**GOWANUS CANAL SUPERFUND SITE  
RECORD OF DECISION**

**APPENDIX V**

**RESPONSIVENESS SUMMARY**

**Figure 1: Comparison of Total PAH Concentrations in Surface Sediment from the Newtown Creek and Gowanus Canal Reference Areas**

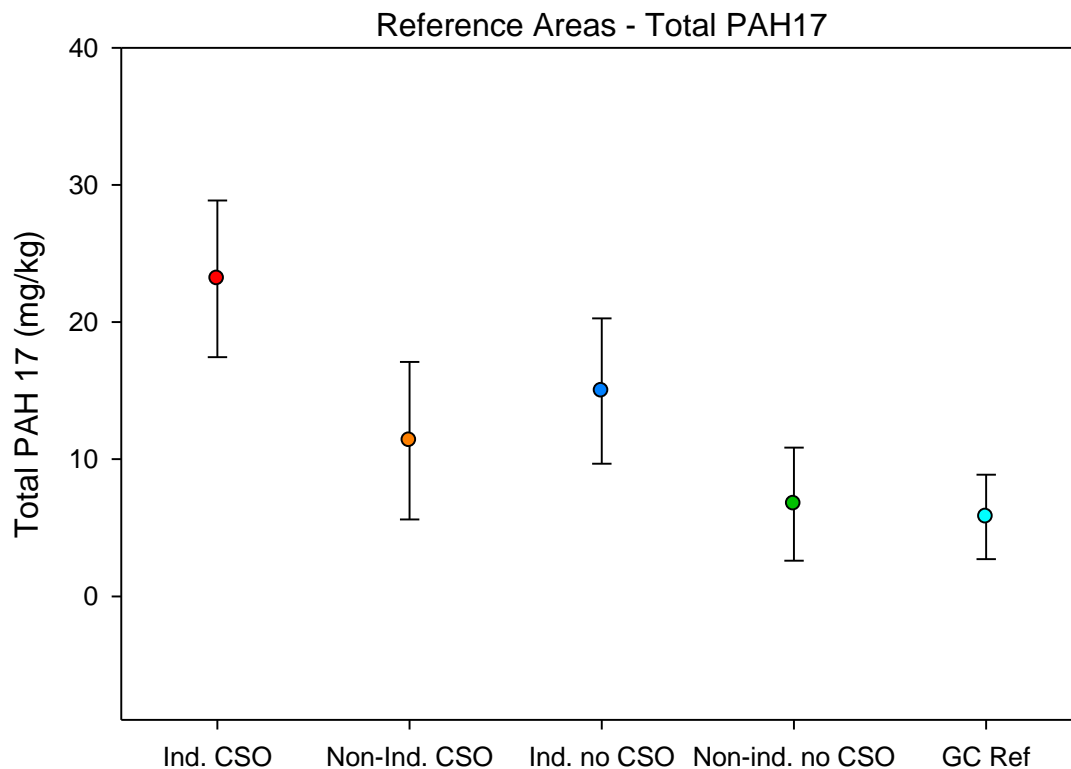
Comment #4: National Grid and NYCDEP commented regarding the selection of the reference area for the canal RI/FS and the use of Gowanus Bay and Upper New York Bay reference area data to predict post-remedy conditions within the canal as follows:

- National Grid noted that the Proposed Plan does not fully acknowledge that the post-remedy environment of the canal will continue to receive stormwater and CSO discharges from heavily urbanized and industrialized properties; there is no basis for concluding that polycyclic aromatic hydrocarbon (PAH) concentrations in post-remedy surface sediments would be near the upper end of the Gowanus Bay and Upper New York Bay reference range (14 milligrams per kilogram [mg/kg]).

Response #4: The sediment remedy will result in a clean cap surface on the bottom of the canal. If the PAH contributions from the former MGP facilities and CSOs were completely eliminated, then the solids-associated PAHs deposited on this clean surface would be derived primarily from solids delivered to the canal from Upper New York Bay through tidal action and the Flushing Tunnel, storm sewers and direct overland flow. The suspended sediments from Gowanus Bay and Upper New York Bay would be expected to have a substantial post-source control influence on sediment quality because less than 10 percent of the canal watershed is drained into the canal by storm sewers and direct runoff (assuming that no high-level sewer separation would occur) However, since CSOs to the canal will not be entirely eliminated as part of the sediment remedy, the newly-established background level of PAHs in surface sediment will depend on the level of CSO reductions achieved. The goal is to reduce the contribution of CSO solids so that the average total PAH concentration in canal's surface sediments after remediation does not exceed the preliminary remediation goal (PRG)<sup>7</sup> of 20 mg/kg.

Although Gowanus Bay and Upper New York Bay are more open than the canal, the sediments in this area provide the best available representation of regional background conditions excluding point source releases and surface runoff to the canal. As reported in the CSO Impacts section of the FS report addendum, the estimated total PAH concentrations on suspended sediments in the surface water samples from the Gowanus Bay and Upper New York Bay reference area are similar to the reference area surface sediment concentrations. Figure 1 indicates that the mean PAH concentration in the Gowanus Bay and Upper New York Bay reference area is similar to the “non-industrial with no or minimal CSO input” category for the Newtown Creek reference area.

**Figure 2: Distribution of Total PCB Congener Concentrations in Surface Sediment Samples**

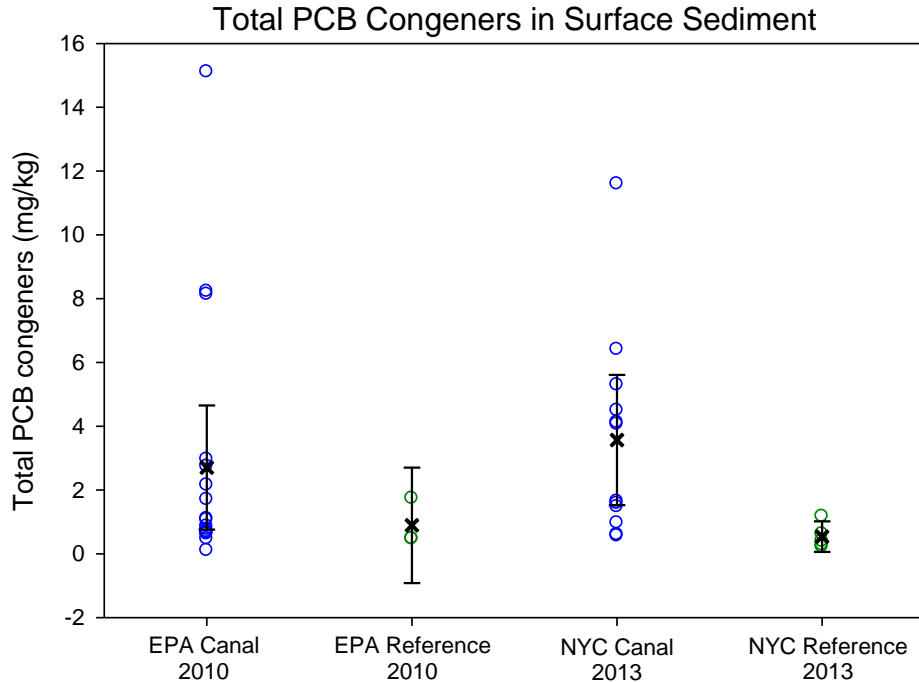
Comment #5: Consolidated Edison (ConEd), a PRP, stated that there is no statistically significant difference between total PCB congener concentrations in surface sediment samples from the canal and samples from the Gowanus Bay and Upper New York Bay reference area.

Response #5: The EPA did not perform statistical comparisons of total PCB congener concentrations because fewer than ten sampling results were available for the reference area samples. Specifically, only three reference area samples were analyzed for PCB congeners, which is an insufficient number for a robust statistical comparison. The statistical comparison of total PCB Aroclor results (27 canal and 10 reference area samples) indicated that the median concentration in the canal samples is significantly higher than in the reference samples. However, as noted in the Proposed Plan, PCB congener data are more reliable for the quantification of PCBs in sediments.

The plot in Figure 2, below, shows the distribution of total PCB congener concentrations in surface sediment samples collected by the EPA in 2010 for the RI. Also shown are the total PCB congener concentrations in samples collected by NYCDEP at a subset of the RI locations in 2013 (including five of the reference area locations). The EPA and NYCDEP results are consistent, and both show that the mean total PCB congener concentration in canal sediments is above the 95 percent confidence interval of the mean reference area concentration. Total PCB congener concentrations of greater than 4 mg/kg were detected in some of the canal surface sediments. Additionally, PCB Aroclor data for deeper soft sediment<sup>9</sup> show concentrations as high as 51 mg/kg (EPA, 2010 RI samples) and 66 mg/kg (National Grid, 2012 CSO mound samples<sup>10</sup>). These results clearly show that some of the surface and deeper soft sediments in the canal are contaminated with PCBs at levels that are substantially higher than reference area concentrations. PCBs in deeper soft sediments may be transported by various events, including vessel scour and storm events.

**Figure 3: Total PCB Congener Concentrations in All Large Fish Fillets Samples for Canal and Reference Area**

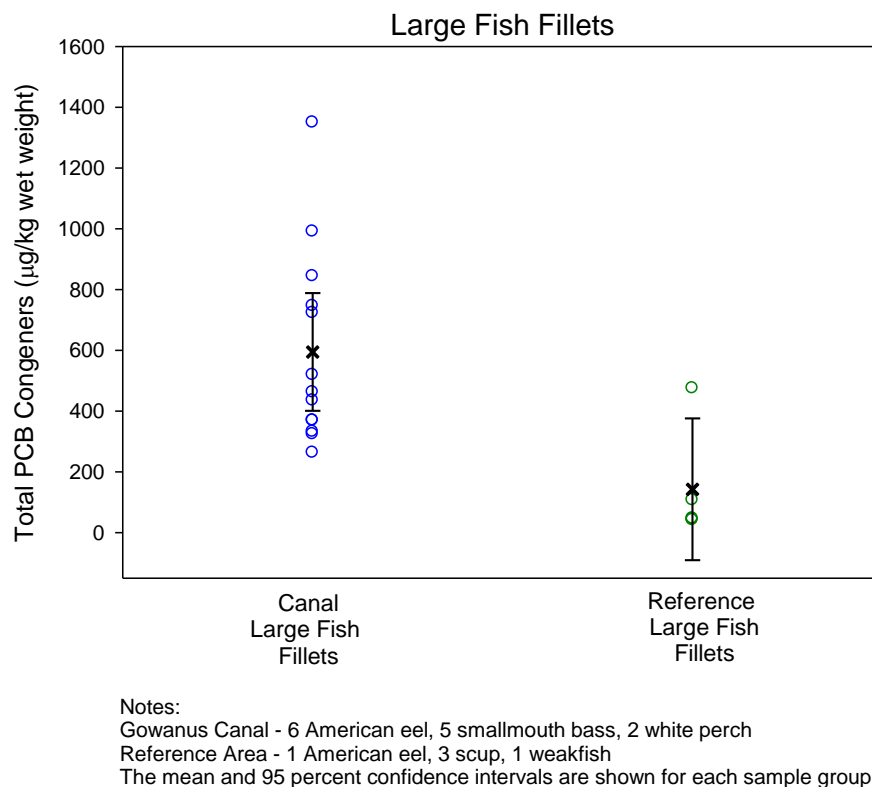
Comment #6: ConEd asserts that the EPA has not supported the assertion that PCB levels in fish taken from the Gowanus Canal are about two times higher than PCB levels in fish taken from the reference area.

Response #6: The Proposed Plan states that the “average concentrations of PCBs in the canal fish and crab samples were about two times higher than the average PCB concentrations in the reference area samples collected from Gowanus Bay and Upper New York Bay.” This statement is based on the comparison of total PCB congener concentrations in American eel fillet and whole body blue crab tissue samples because these were the only species evaluated in the human health risk assessment (HHRA) that were caught in both the canal and reference area. Although striped bass and white perch were caught in the canal, none were caught in the reference area, so direct comparisons were not possible. The average concentration of total PCB congeners in the eel fillet samples from the canal (six samples) was 862 micrograms per kilogram (µg/kg) wet weight, which is 1.8 times higher than the concentration in the single American eel fillet sample from the reference area (475 µg/kg wet weight). The average total PCB congener concentration in whole body blue crab from the canal (12 samples) was 157 µg/kg, which is 1.7 times higher than the average concentration in the reference area samples (91 µg/kg; eight samples).

The concerted fish and shellfish collection effort undertaken for the RI did not yield sufficient numbers of samples of the same large fish species from both the canal and reference area to perform robust statistical comparisons. The plots in Figures 3 and 4, below, show the total PCB congener concentrations in all large fish fillets and whole body blue crab samples for the canal and reference area. Although the results for the large fish fillets reflect a different mix of species in the canal and reference area, the data collected to date indicate that PCB concentrations in large fish and crab tissue are higher in the canal than in the Gowanus Bay and Upper New York Bay reference area.

Figure 8: PAH Distribution for Hot Spot and Non-hot Spot Locations

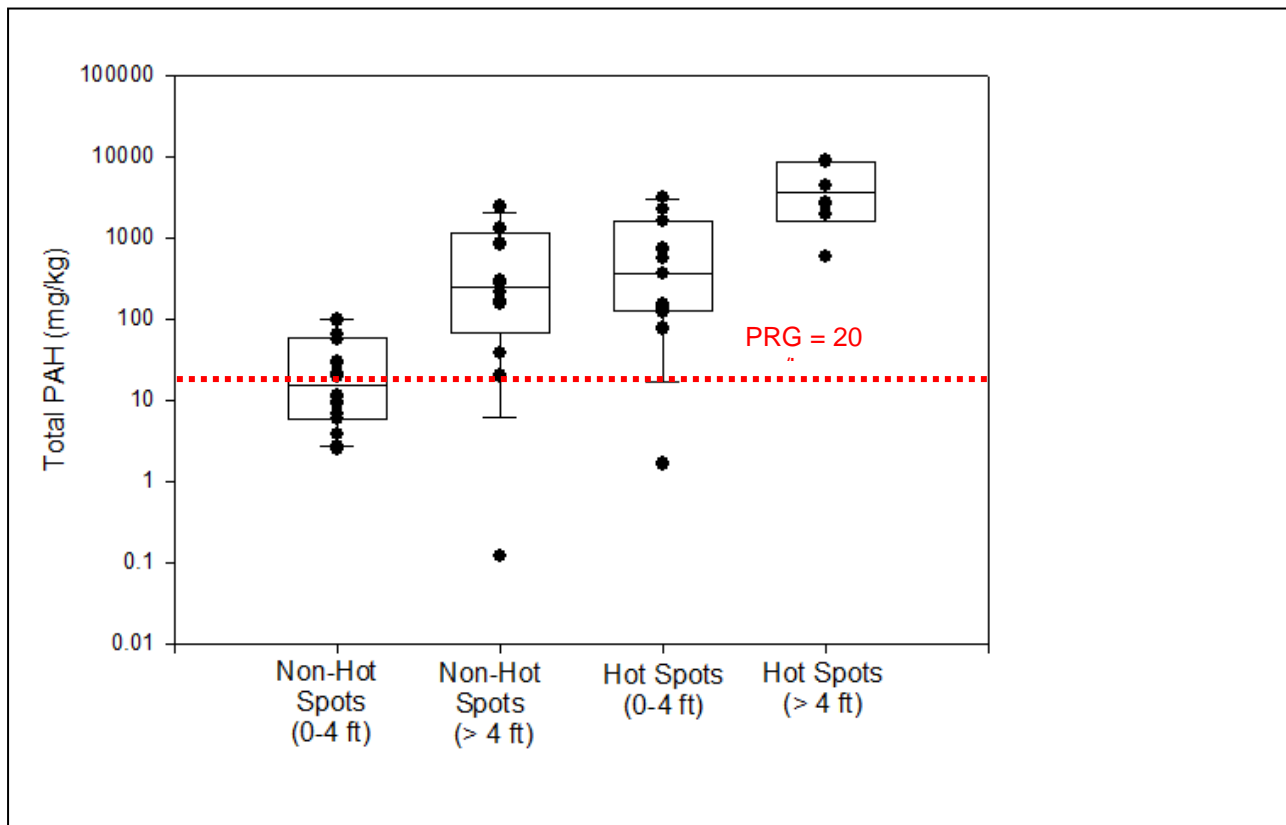
National Grid also asserts that the sediment chemistry is different in RTA 3 and sediments in RTA 3B contain lower concentrations of potentially toxic chemicals than much of the rest of the canal.

Response #191: The EPA has reviewed the data set cited in the comment concerning contaminant distribution and hot spot and non-hot spot locations in RTA 3B. The total PAH distribution for hot spot and non-hot spot locations are presented in Figure 8, below. The EPA elected to divide the data sets in two depths: depths from zero to four feet below the sediment surface and depths greater than four feet below the sediment surface to match the depth intervals used by the commenter in their analysis. The basis for this division was that in the near surface sediments exposure to benthic communities occurs and natural recovery could be expected to have a greater effect.

The data analysis confirms the comment that the non-hot spot locations have lower total PAH concentrations in the sediment in the top four feet compared to the deeper sediments at the same locations. However, the data also show that whereas the median concentration for the non-hot spot locations in the upper four feet of sediment is near the PRG approximately 50% of the samples collected were above the PRG. All non-hot spot locations at depths greater than four feet were also above the PRG. The above analysis confirms the EPA's previous conclusion that soft sediment removal is required in RTA 3B.
